14 September 2006  
E&L-033-06

Subject: Special Package Authorization for the LACBWR Reactor Pressure Vessel Package (TAC L23931)

1. Revised drawing C-068-163041-002, Rev. 1, RPV Canister Assembly – a note was added that Item 5 is optional
2. RPV surveys after grouting

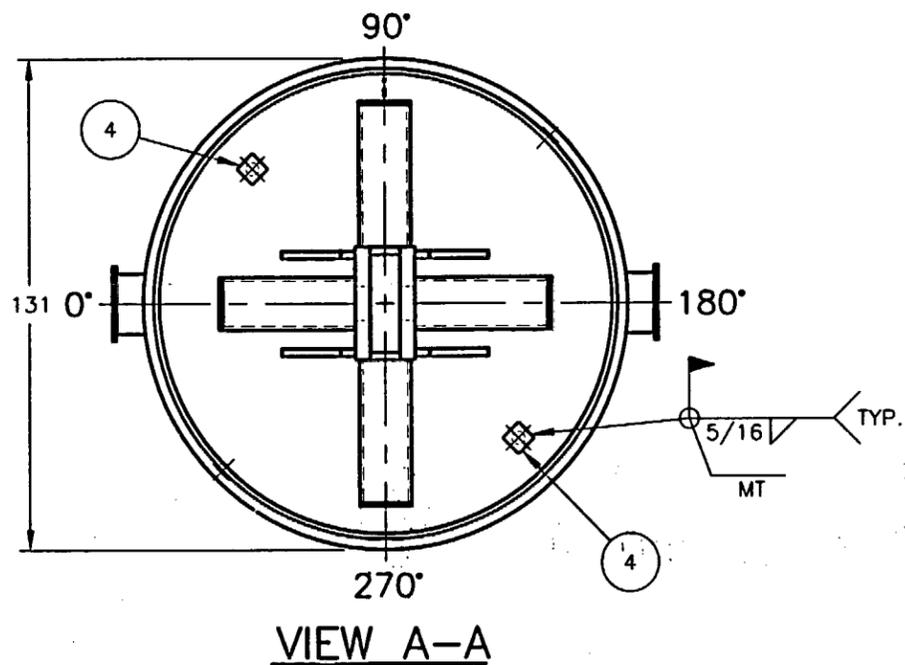
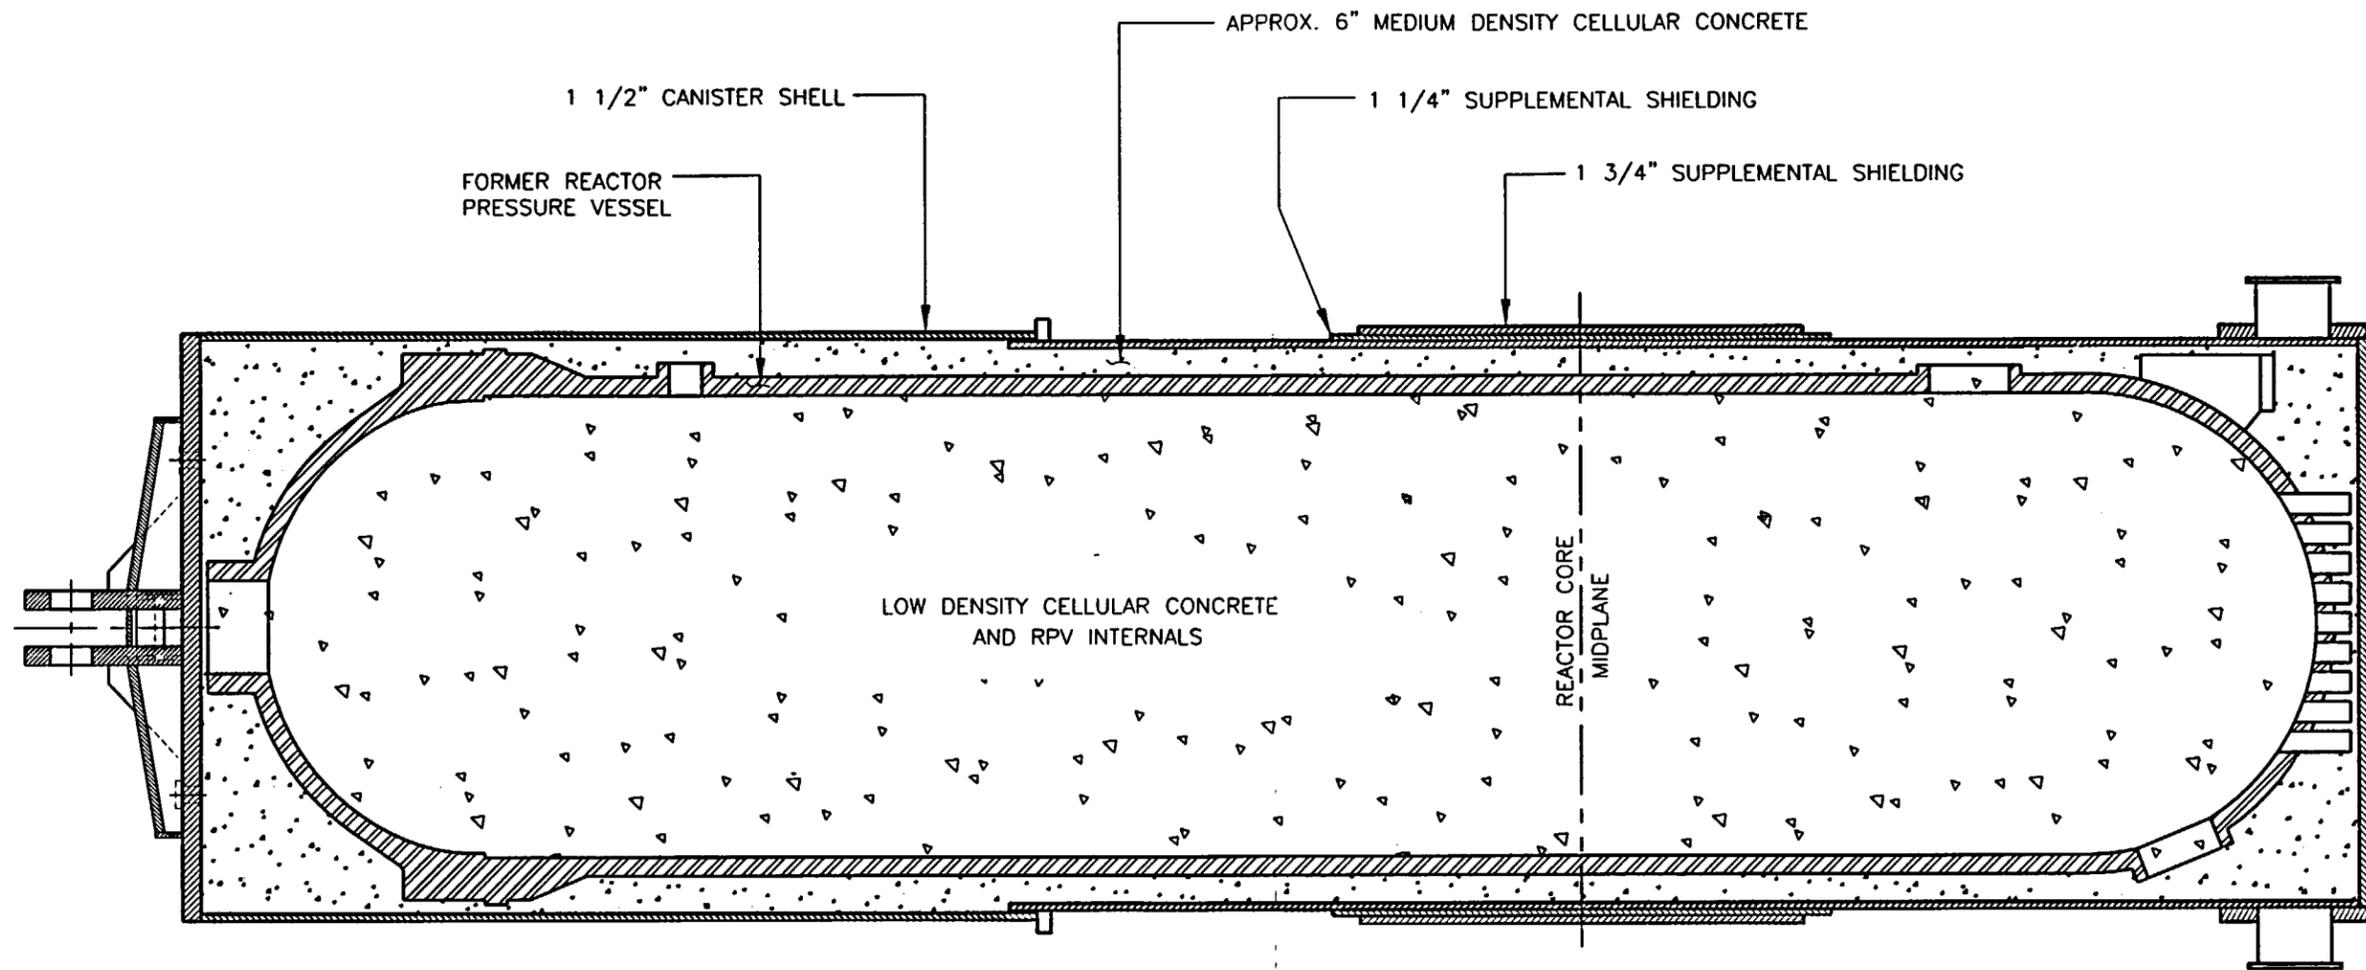
No changes to the SAR are required except for a revision to the canister drawing. The structural analysis of the LACBWR RPVP is not affected by changing the Supplementary Shields to optional. They were assumed to detach under HAC and did not provide structural support under NCT. The other sections of the SAR are similarly unaffected.

- 1. THE LIFT ASSEMBLY AND TRUNNIONS ARE DISABLED PRIOR TO SHIPMENT.
- 2. OPTIONAL, ATTACH IF NECESSARY TO COMPLY WITH 10CFR71.47.
